**Planning Board – Monday, August 27, 2018, 6:30PM**  
**City Hall Council Chambers – 3 Washington Street, 2<sup>nd</sup> floor**  
**AGENDA**

# CITY OF KEENE | PLANNING BOARD

## SPR-847, Modification 1: SITE PLAN REVIEW – Sunset Tool, 58 Optical Ave.

Figure 2: Detail of Existing Shed at Proposed, New Property Line

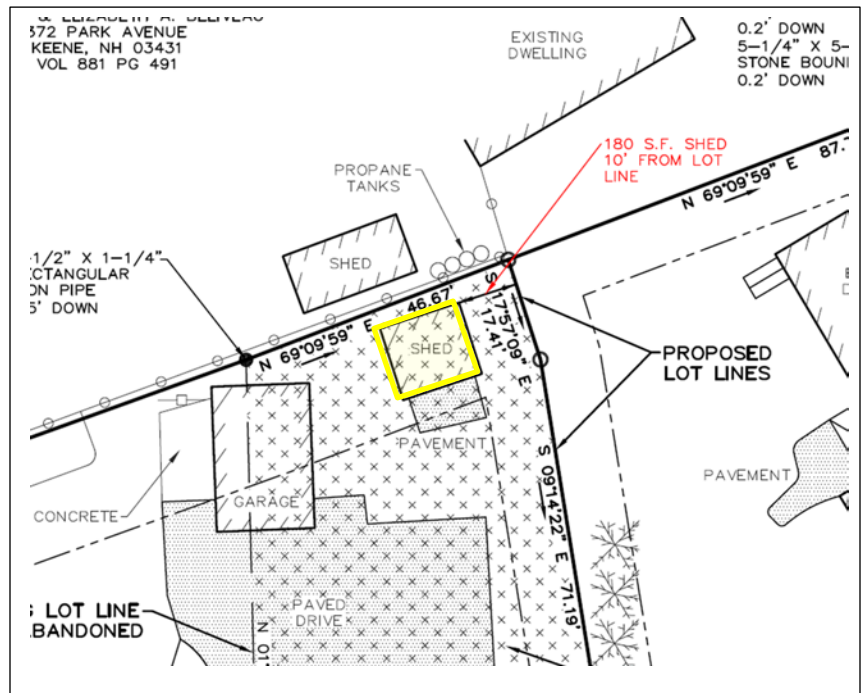
Code: Initial concerns regarding the setback of the existing shed were resolved by the applicant re-submitting a modified plan showing the required 10’ setback for the existing structure. See Figure 1.

SCALE: 1"=20'  
 DATE: JULY 20, 2018  
 SHEET 1

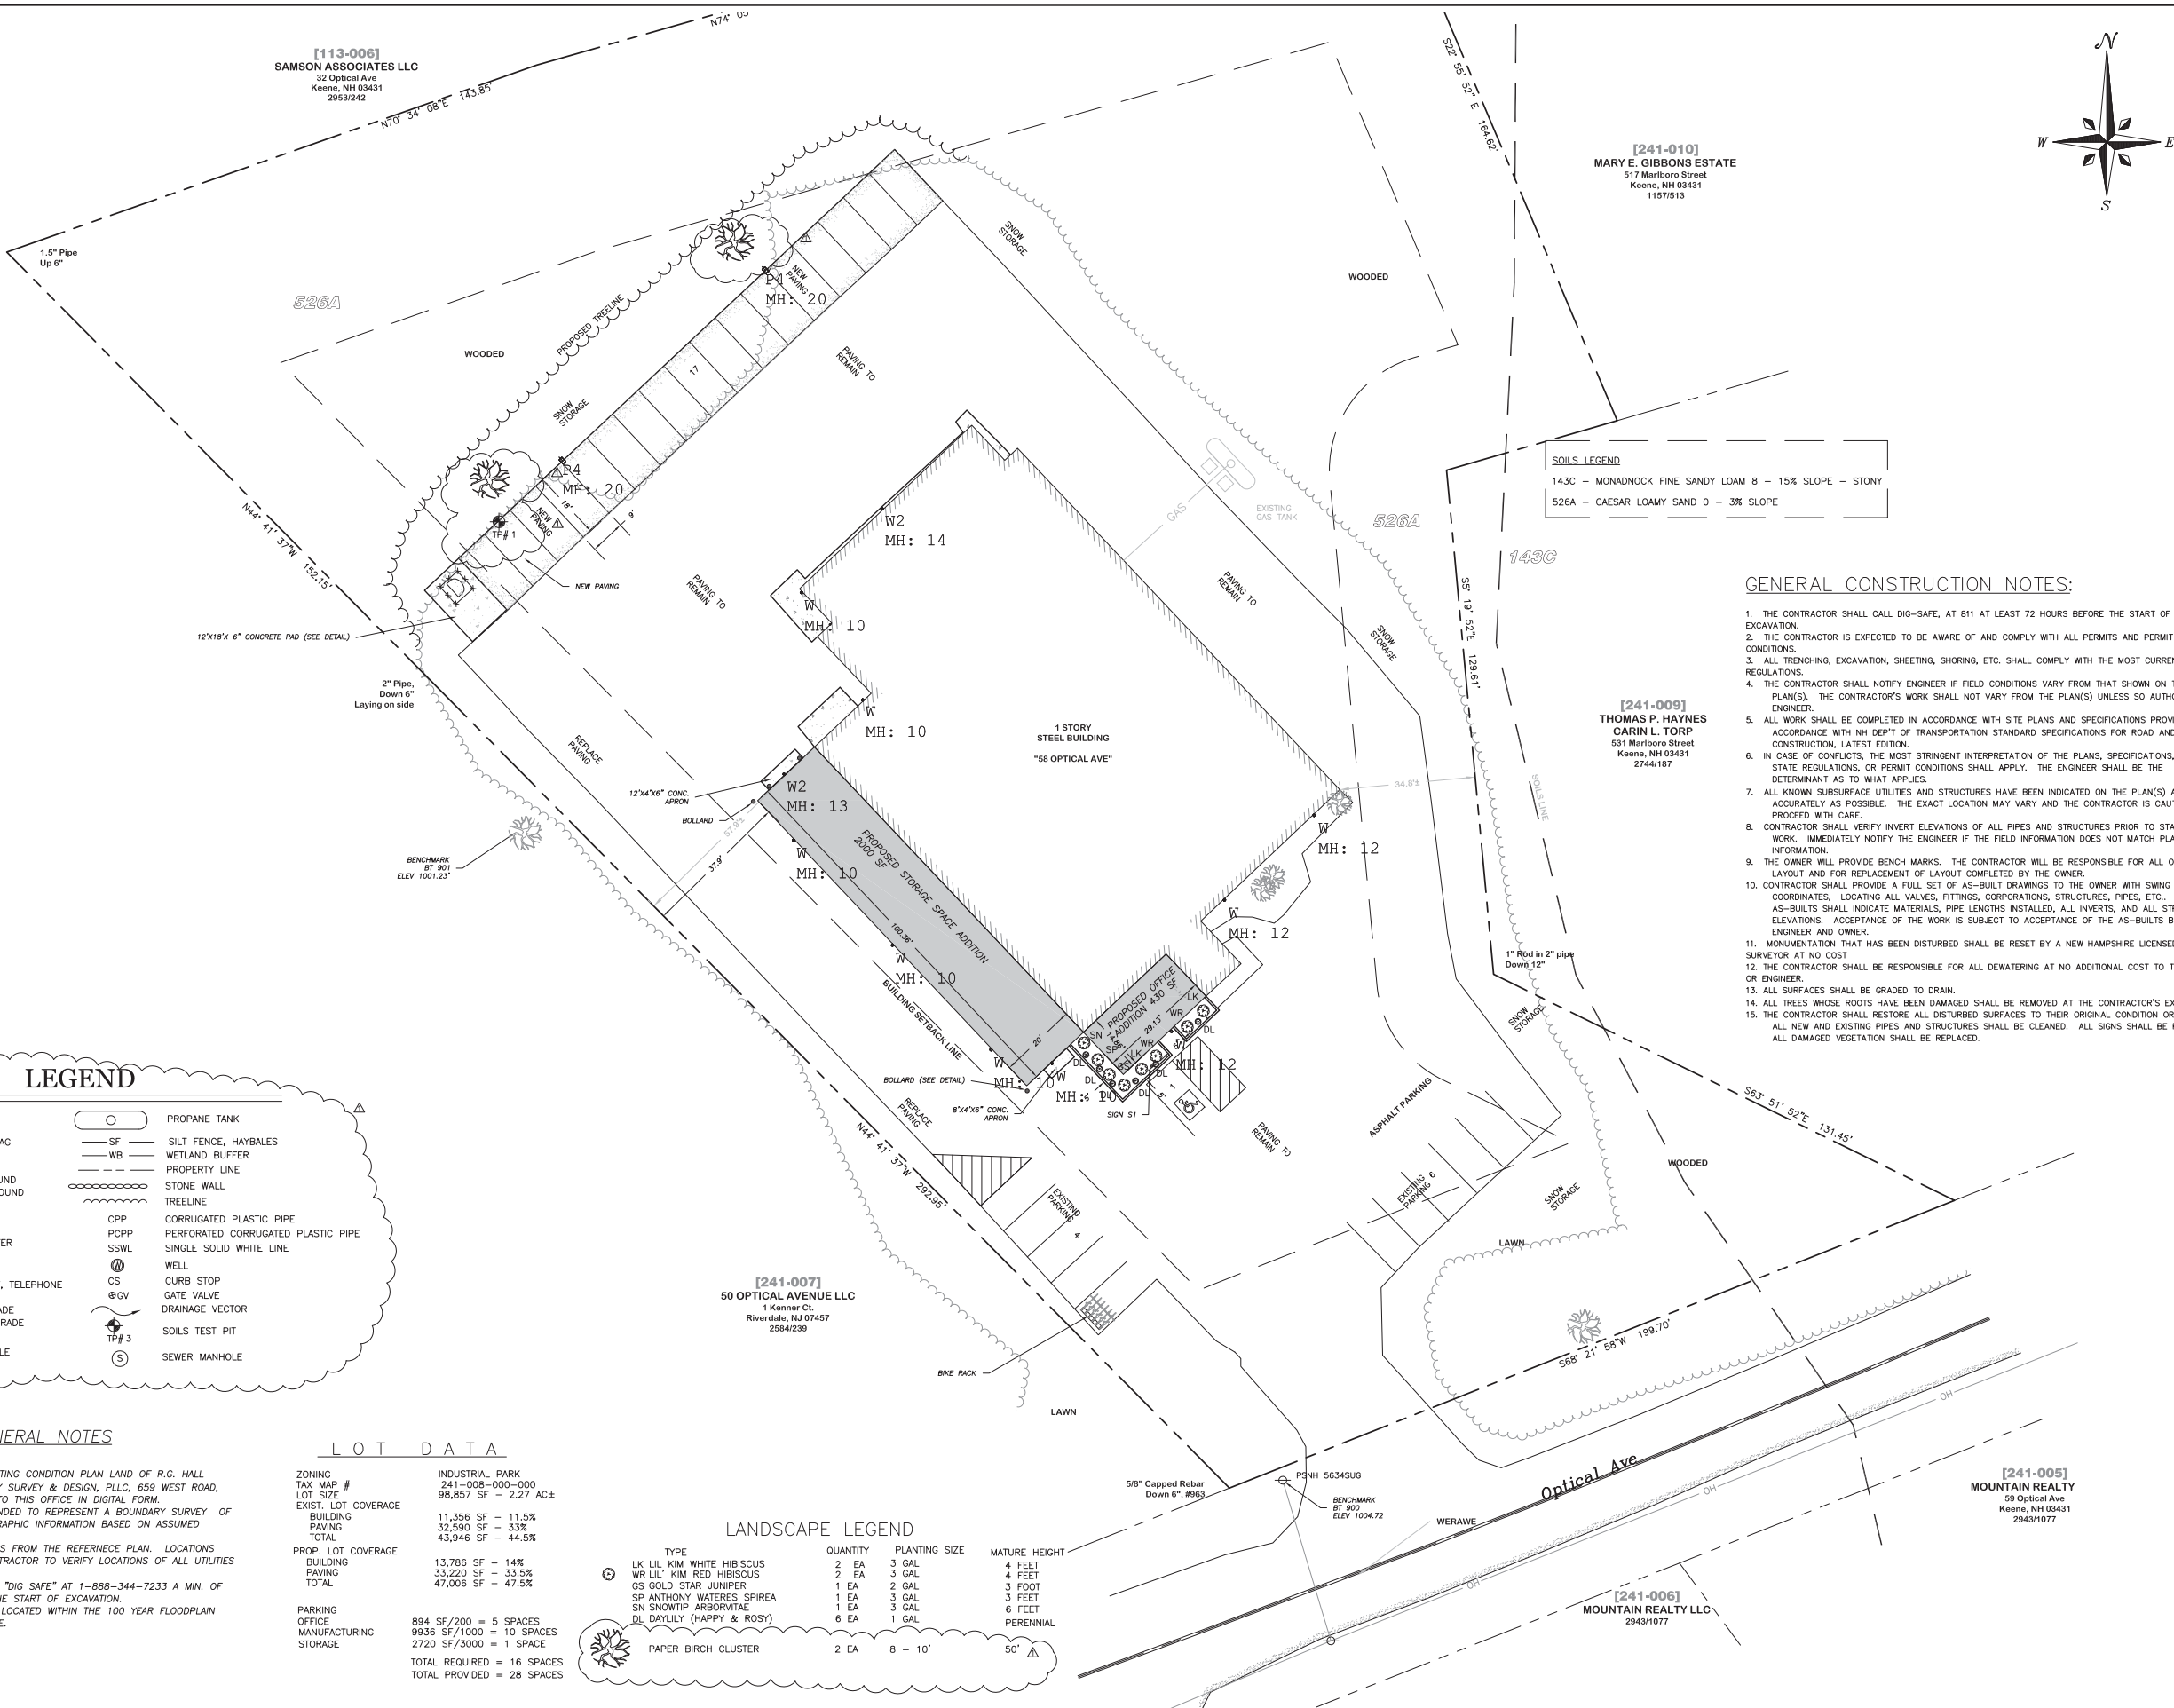
1. Section 102-1226, side paving setbacks for Medium Large lots is 10', the plans scale at about 3'.
2. Section 102-794, the new parking at the rear and side shall have bumpers or curb like stops.

1. Please confirm that all symbology used in the drawings is defined correctly in the legend (e.g., Storm drain line, Drain Manhole, etc.).
2. Show locations of soil percolation tests.

- b. Per Development Standard 1.b.3. The seasonally high groundwater table SHWT is communicated by a Test Pit detail on Sheet 1, the "Existing Plan" states that there was "no observed water table" at the bottom of the 36" depth soil boring hole. This same detail notes the sharply drained percolation rate of 1 min/inch at 30". A drainage report was submitted by Thayer Fellows, PE. This standard has been met.

- 1. Submittal of revised Landscape and Lighting plans to meet the City’s Development standards, acceptable to the Community Development Director.*
- 2. Prior to signature, submittal of security for site stabilization, landscaping and an “as-built” plan in a form and amount acceptable to the Community Development Director and City Engineer.*
- 3. Prior to signature by Planning Board Chair, Owner’s signature on plan.*

SHEET 2

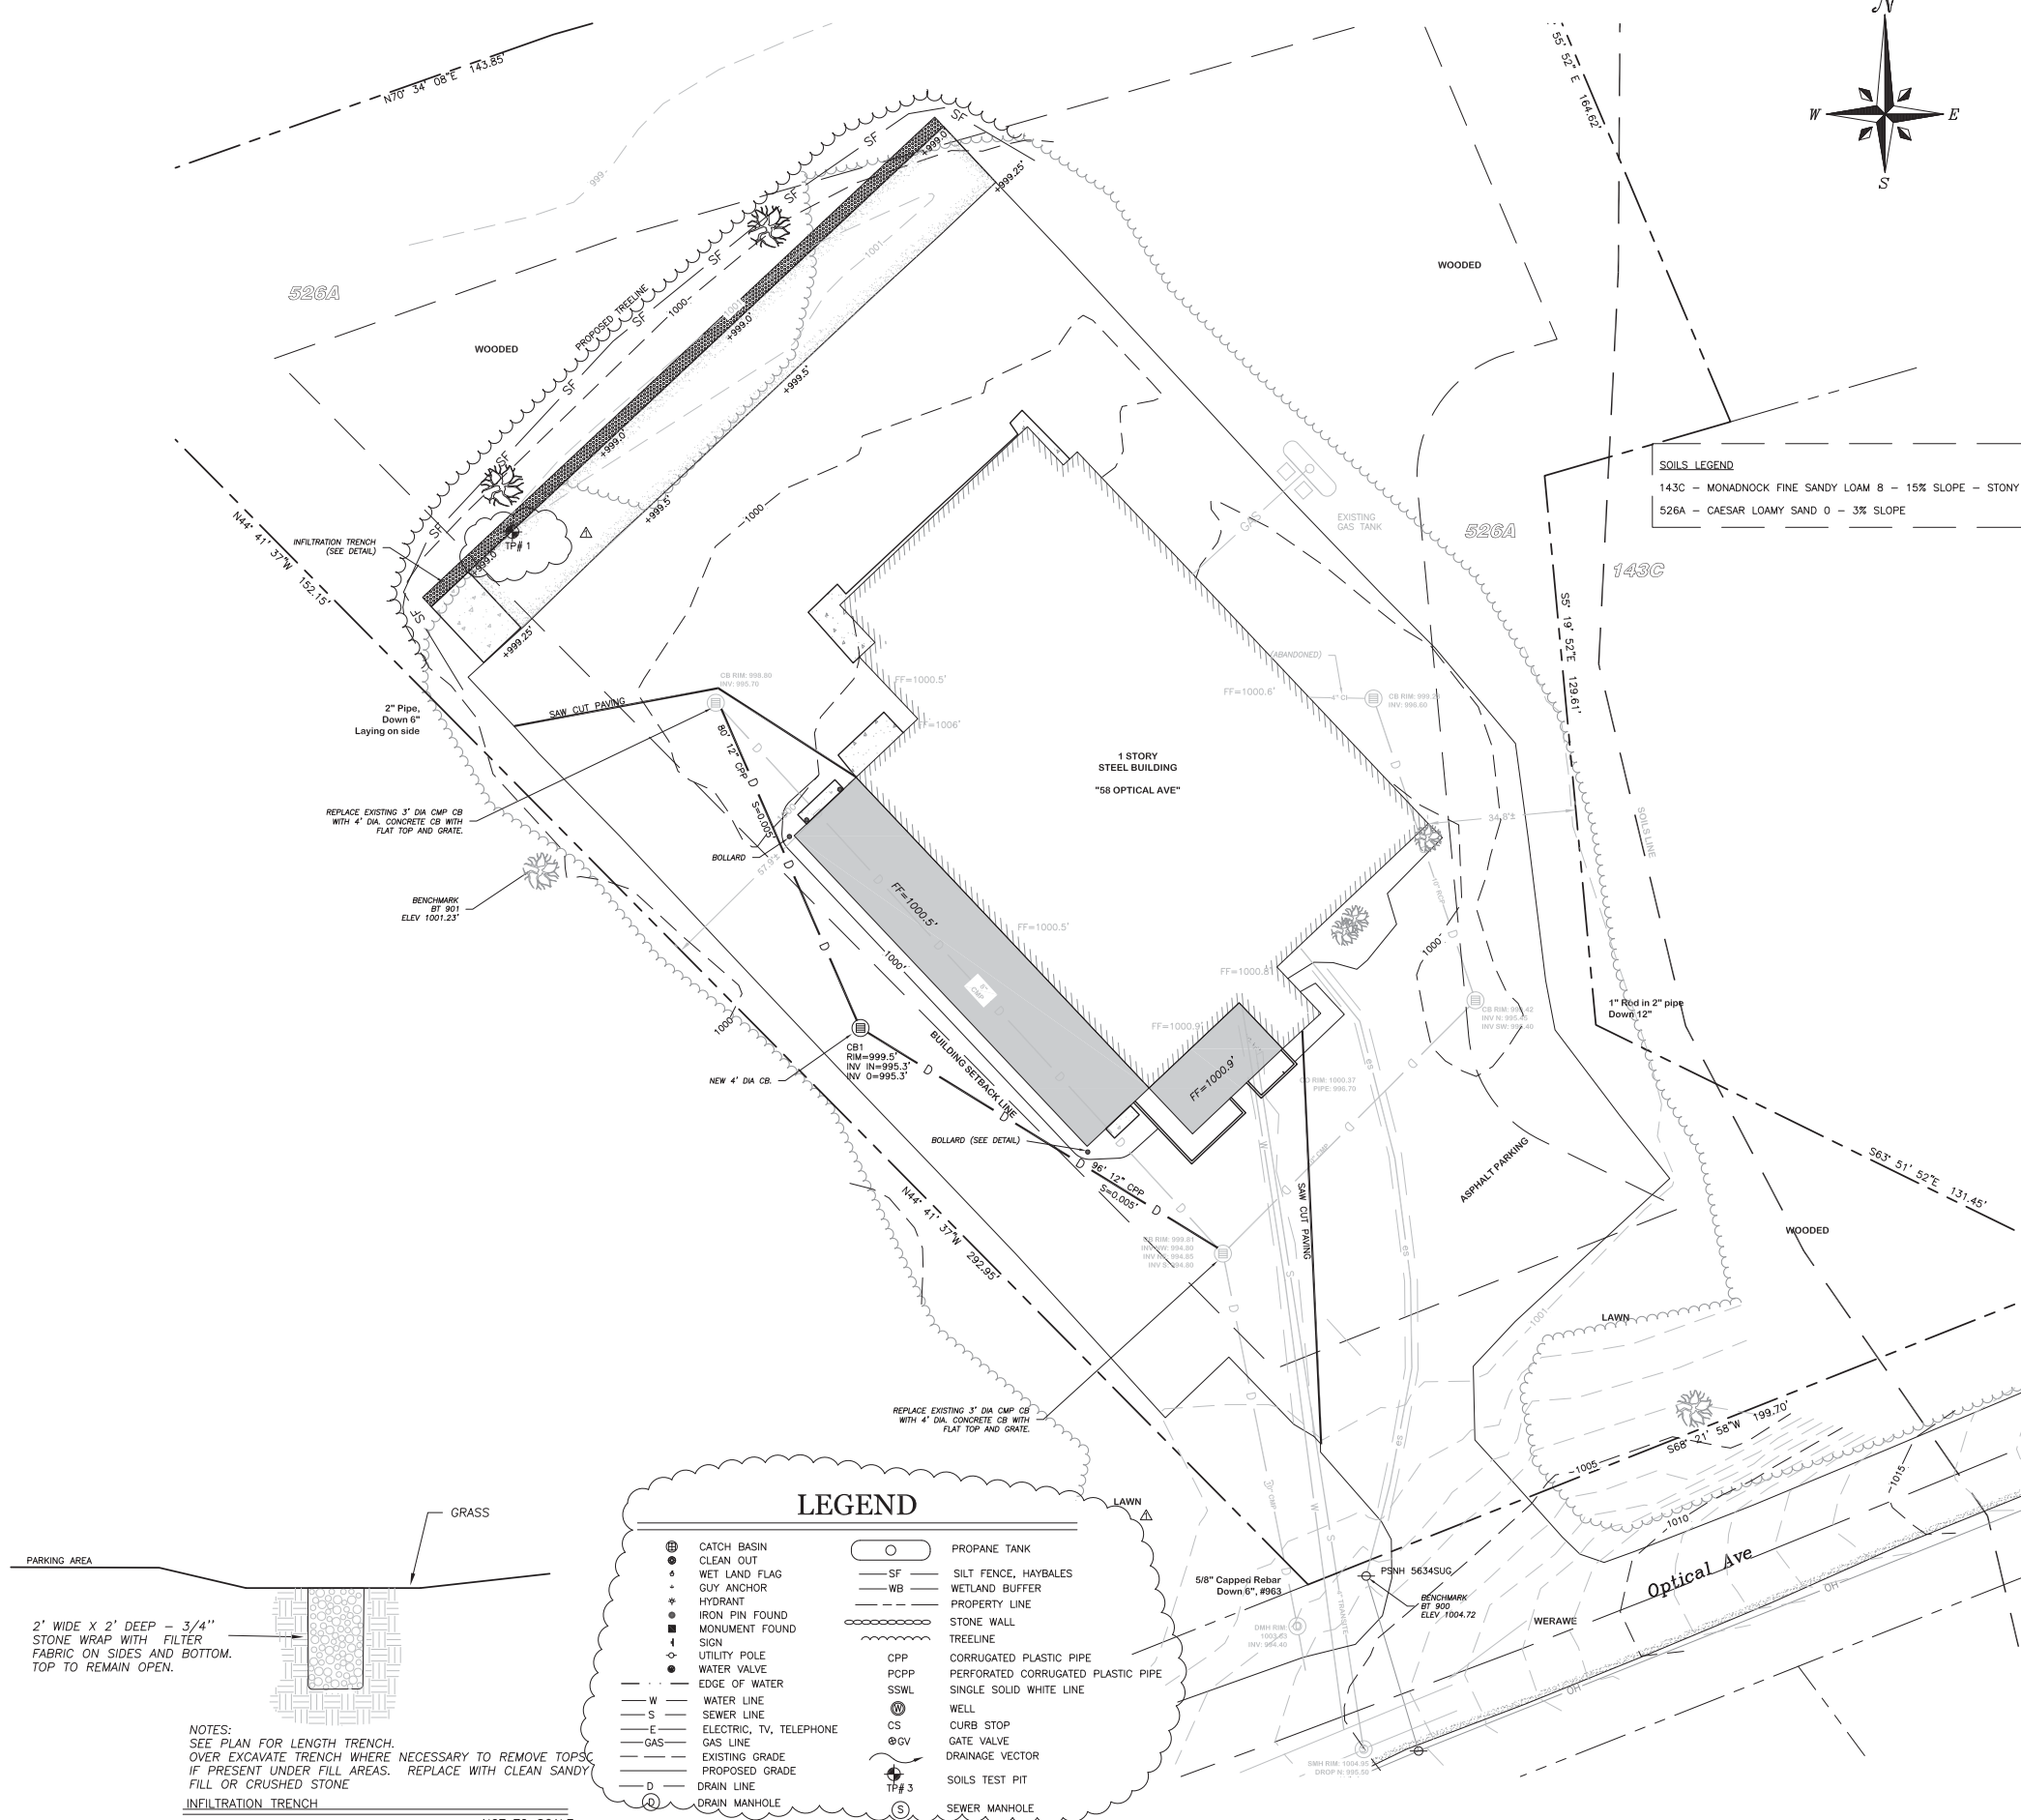
6. Landscaping:
  - a. Per Development Standard 6. A number of new shrubs and perennials are shown on sheet 2 to be planted at the new front entrance.
  - b. Per Development Standard 6.b. "For parking lots having parking lots of 10 or more spaces:

The submitted "Location and Landscape Plan" shows 2, 8-10' tall "Paper Birch Cluster". This specification does not meet the standard for the 28 parking spaces shown on the site plan. The Board may wish to discuss this circumstance with the applicant so that either:
